Stage II Decommissioning Questions and Answers

Revised September 26, 2012

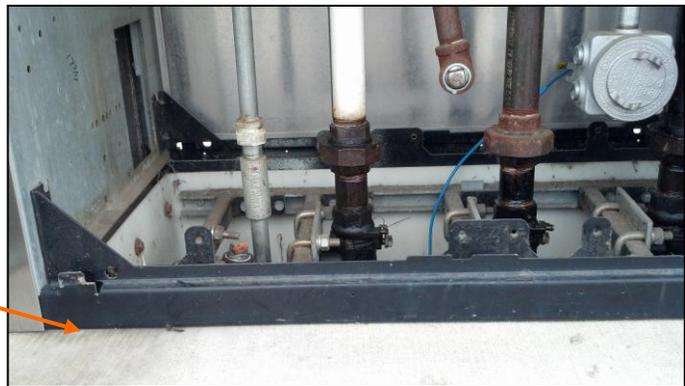
Considerable discussion related to the stage II piping disconnection from the dispenser, typically at the shear valve. What is acceptable, what is the dispenser base line of demarcation, etc.?

- * How the disconnection is made is up to the service contractor. The break must be below the base of the dispenser. The base of the dispenser is considered to be where the dispenser base rail frame meets the concrete.

- * If the top of the shear valve is above the baseline of the dispenser it must be lowered. This may involve fabricating a bracket to secure it to the original or new mounting support hardware. To accommodate field fabrication and maintain an inspection tolerance dimension the measurement tolerance is no more than 3/8" above the base.
- * The shear valve cannot be dropped into the dispenser sump creating the potential to become a collection point for debris or impeding a sump sensor.
- * The response to item 3a states: *"Ideally, the disconnect and plug will be at the lowest point possible or at a point closest to where the vapor line enters the sump . . ."* While this point of disconnect is not a requirement, it is still an ideal method because it removes an inactive component from the dispenser sump allowing better access for inspection, maintenance and service.
